Colorado Department of Health

Review and Comment

Final Phase I RFI/RI Workplan for OU 10

May, 1992

FIGURE 7.3-2  
Proposed Sampling Locations for  
Oil Leak (IHSS 129)

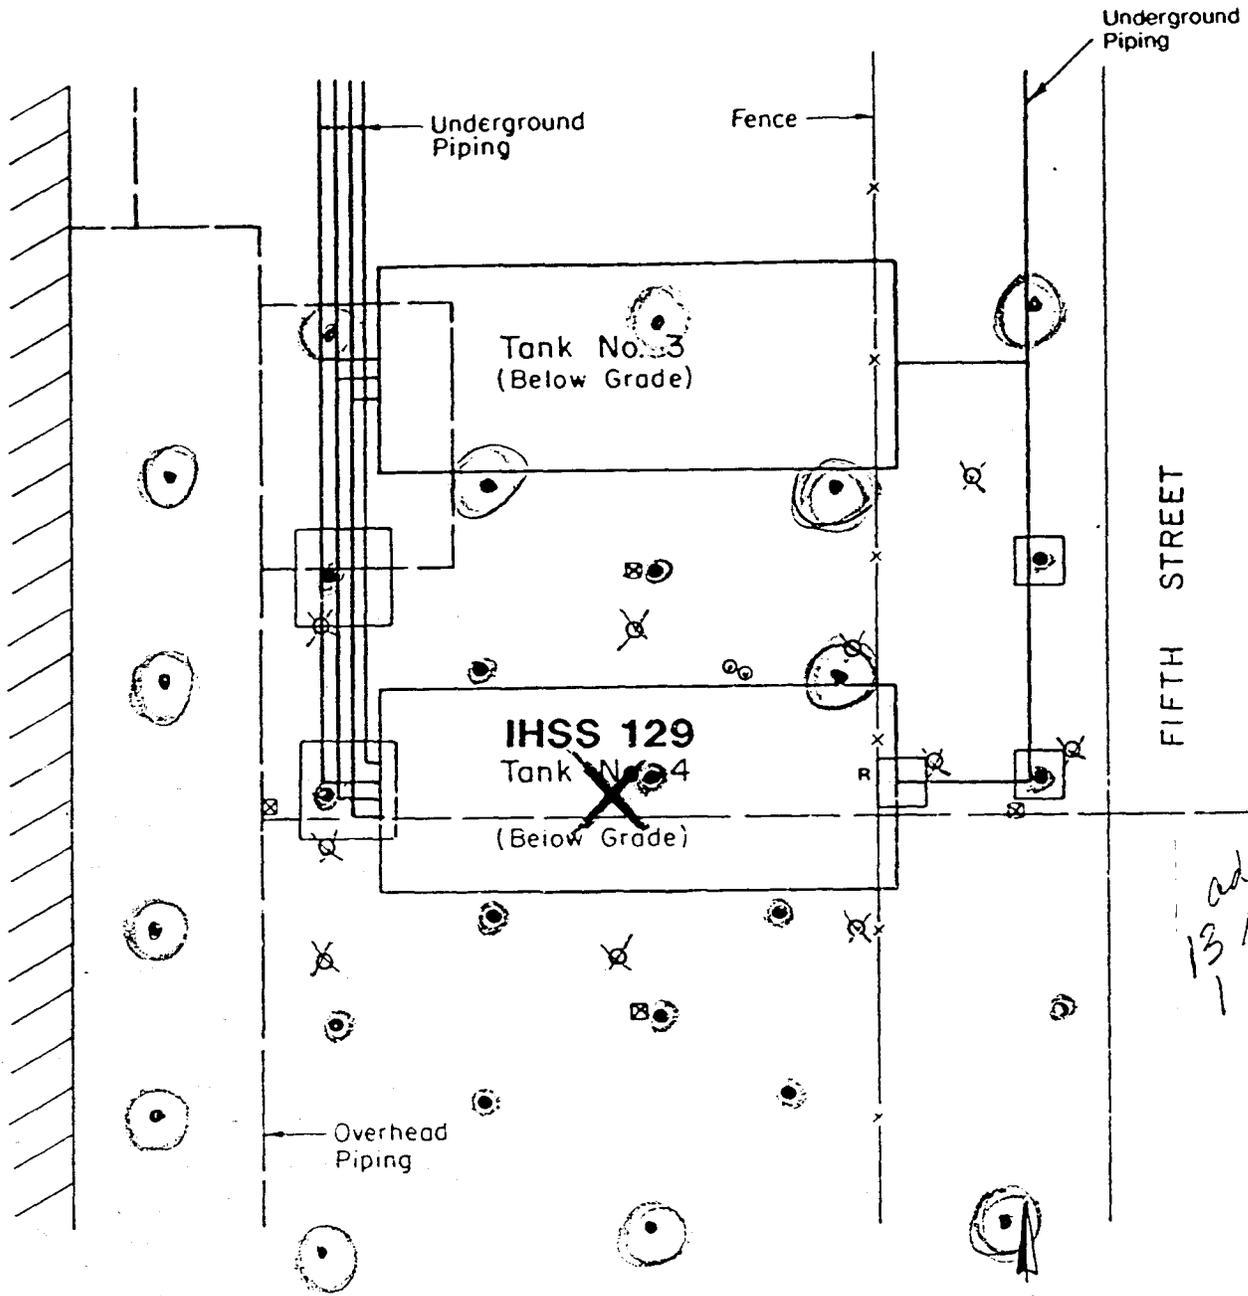
Also, the text indicates that three lines of soil gas sampling are planned which does not agree with Figure 7.3-2. Please correct the text.

Figure 7.3-2: The Division asks that, regardless of the outcome of the discussions mentioned in the previous comment, the soil gas survey and the surficial soil sampling program be expanded. Please refer to the attached version of Figure 7.3-2 with the Division's recommendations for program expansion (13 additional soil gas locations, 1 additional soil sample).

**X** add soil sample  
**⊙** add soil gas sample

*add -  
13 soil gas  
1 soil sm*
